ADMINISTRATIVE APPLICATION CHECKLIST SR016 SWD #1

Amendment To Lower Bottom Disposal Interval

RE: Request to Amend C-108
Administrative Order SWD-1195
Marbob Energy SRO 16 SWD No. 1
1980' FNL, 1980' FEL
Unit G, Section 16, T26S-R28E
Eddy County
API #30-015-21398

COMPANY: MARBOB ENERGY CORP. WELL: SRO 16 SWD #1

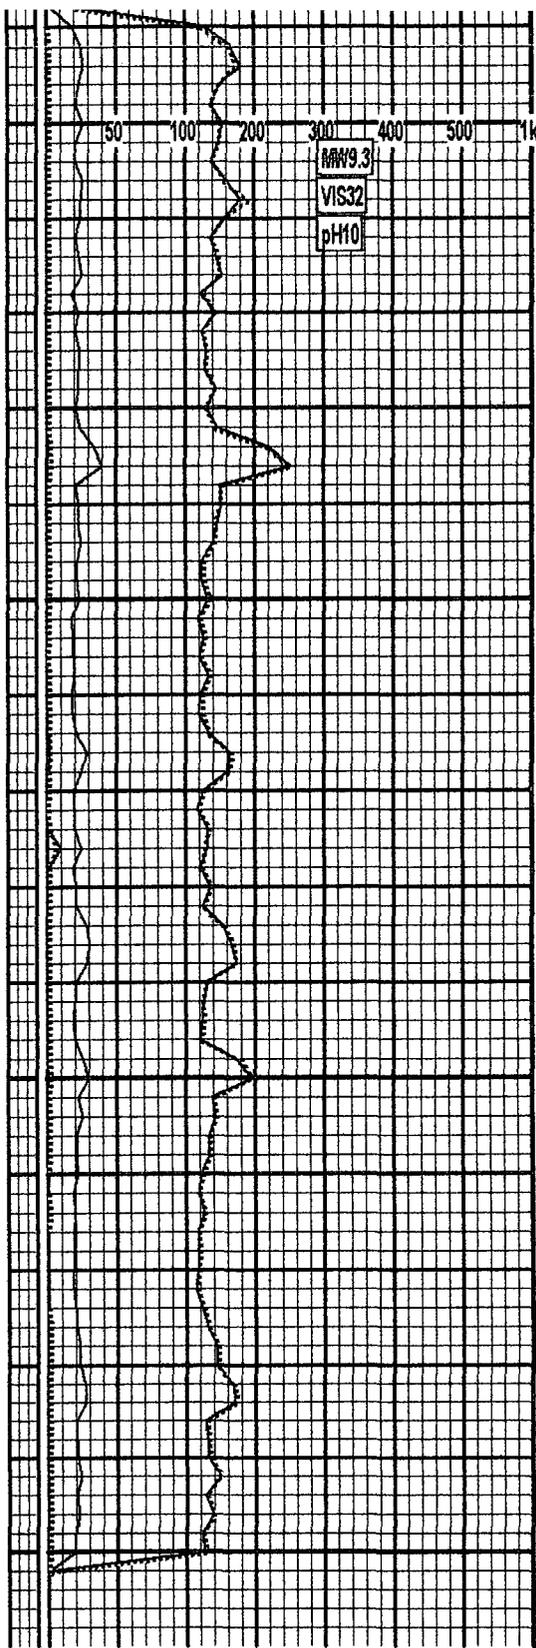
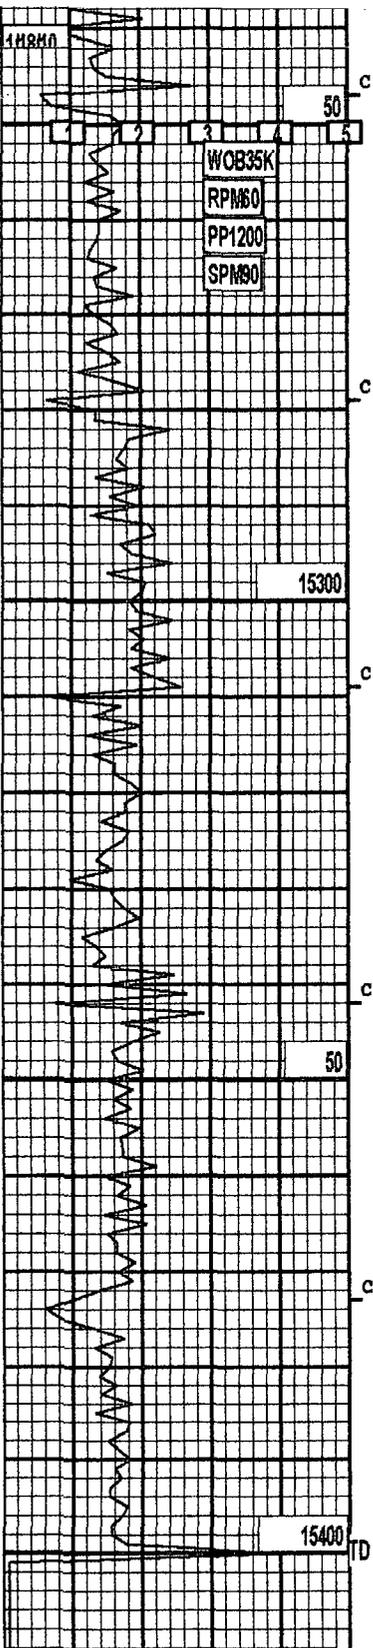
Marbob Energy requests approval to modify the captioned SWD Order -1195 to increase the bottom of the Devonian open hole injection interval from 15100' to 15400', a 300' increase in depth. While deepening to the originally proposed TD of 15100', we encountered 200' of slow drilling, tight limestone. This effectively reduced our proposed open hole disposal interval by 200'. We decided to drill the well 300' deeper in hopes of getting back into porous dolomite to ensure that we will have a high capacity, long term Devonian SWD well that justifies the over \$3,000,000 we have spent on it. We did get into porous dolomite in the bottom portion of the well as hoped.

We believe that we are still in the Devonian formation and did not see any significant shows while deepening below the intended target depth (mudlog is attached). There are no producing intervals below the Pennsylvanian aged Morrow in this area. This well was originally drilled as a Devonian test in 1974. The Devonian tested water on a DST and the well was plugged.

Top Limn 14840'

Baseline
15040'

Drillers TD 15,400'
